Public Hearing Report Attachment B

Regarding Tidal Wetlands License Under COMAR 26.24.01.05.H.

<u>Application No.:</u>	17-WL-0367	<u>Date:</u>	January 22, 2018
<u>Applicant:</u>	James and Janet Clauson	<u>Time:</u>	6:00 PM
<u>MDE Staff</u>	Andrew May April Field Heather Hepburn	<u>Location:</u>	Severn Community Library 2624 Annapolis Road Severn, MD 21144

Figure 3

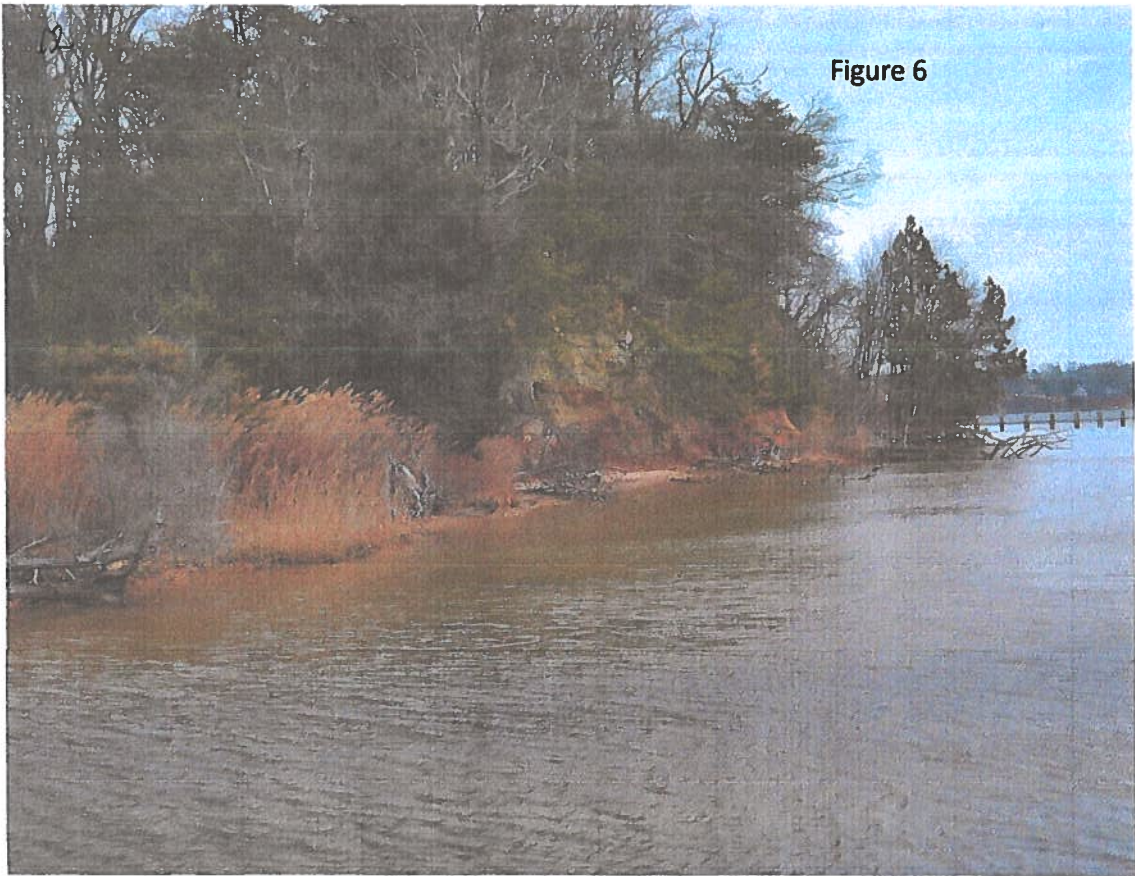
The long term shoreline change along the Kyle Pt/Fox Creek reach is shown in Figure 3. This data is from the MD shoreline data base. The 1845 shoreline is curious and questionable but the rest indicate the erosive nature of the reach. There are several pertinent shore features in Slide 4, 2002 imagery. Kyle Point is modest spit feature with an associated shoal extending eastward offshore. This indicates a net eastward direction of sediment transport from the shoreline upriver of Kyle Point. The shoreline south of Kyle Point extends about 600 feet to an existing rock revetment. This subreach of shoreline occurs as a narrow beach and the offshore shoal from Kyle Point turns sharply landward, narrowing, before moving back offshore in front of and along the rock revetment. The nearshore shoal then turns back landward and continues along the Clauson project reach to Fox Creek. The revetment is about 300 feet long.

Figure 7 : Section 4+27 at 1:1, no vertical exaggeration

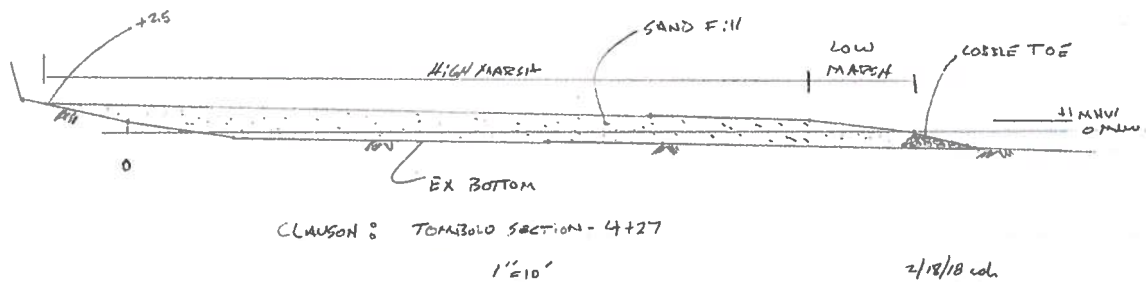
The Clauson shoreline project is not your typical sill. The headland breakwater nature is always a good start for providing shore protection. However, the sand fill is being held by a low cobble toe on the distal end of each headland with wetlands plantings and the low marsh down to MLW, the top of the cobble toe (Figure 7). During modest wind/wave events the sand fill will most likely shear landward and laterally depending in wind direction and water level. An established wetlands planting would reduce this but a modified fill gradient should be expected.

The concern about sand fill being released into the littoral system and adding the Fox Creek maintenance effort could be reduced by raising the cobble toe to be more of a sill structure particularly on the end and south side of the southernmost headland (Figure 8). This modification, to say + 2 MLW, would make the structure more capable of reducing wave action onto the planted marsh, reduce shear, maintain the fill and allow the plantings to take hold thereby providing a more predictable long term stable system.
